# NORTHEAST UTILITIES

Docket No. 50-423  
B11092

Millstone Nuclear Power Station, Unit No. 3  
Submittal of Responses to 480 Series Questions

Remaining 480 Questions not forwarded in Amendment 7

FIGURE Q480.35-1  
 CONTAINMENT HYDROGEN  
 MONITORING SYSTEM  
 MILLSTONE NUCLEAR POWER STATION  
 UNIT 3  
 FINAL SAFETY ANALYSIS REPORT

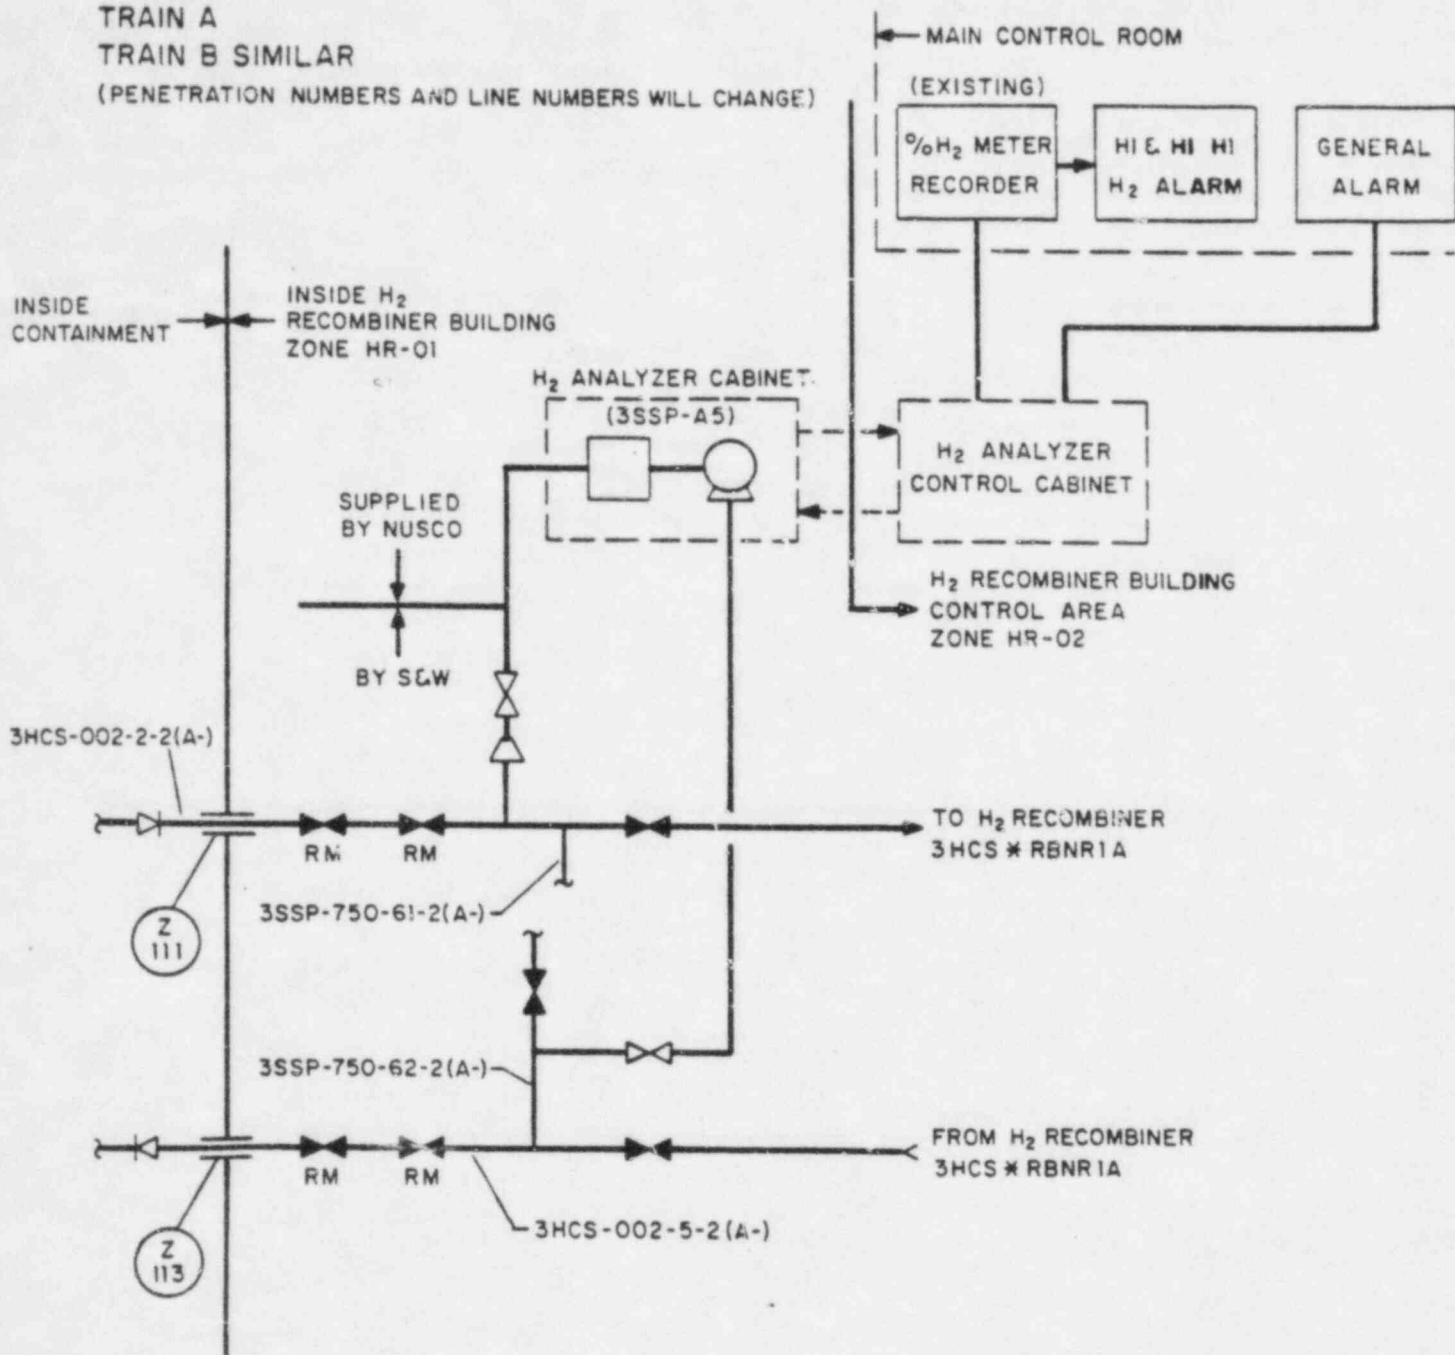
Provide a description of the instrumentation used to monitor containment pressure, temperature, and containment hydrogen concentration. In your description of containment instrumentation, provide the information requested in Section IIF.1 of NUREG-0737.

Four redundant capacitance-type Rosemount Model 1153A absolute pressure transmitters, range 0-60 psia, are provided on Millstone 3. Two additional redundant Rosemount transmitters (same model and type), range 0-200 psia, are provided for extended range measurement (three times containment design pressure). All six transmitters have indicators on the main control board and two of the four channels of the normal range transmitters are continuously recorded, while one of the two extended range channels is recorded. Accuracy of the transmitter is  $\pm 0.25$  percent and response time is 0.2 seconds for transmitter output to reach 63.2 percent of the final value for a step change. All transmitters and channels are designed and qualified in accordance with Regulatory Guide 1.97, paragraph 1.3.1.

Two redundant 200 ohm platinum resistance temperature detectors are provided with indication on the main control board. One channel is continuously recorded. RTD calibration is 0-400°F, accuracy is  $\pm 1.0$  percent, and response time is 5 seconds for sensor output to reach 63.2 percent of the final value for a step change. Both channels are designed and qualified in accordance with Regulatory Guide 1.97, Paragraph 1.3.1.

The system will have analog output for display (two meters), recording (Train A only), and alarming in the main control board. Input is also provided to the plant computer.

Figure Q480.35-1 shows the location and general arrangements for the hydrogen monitoring system.
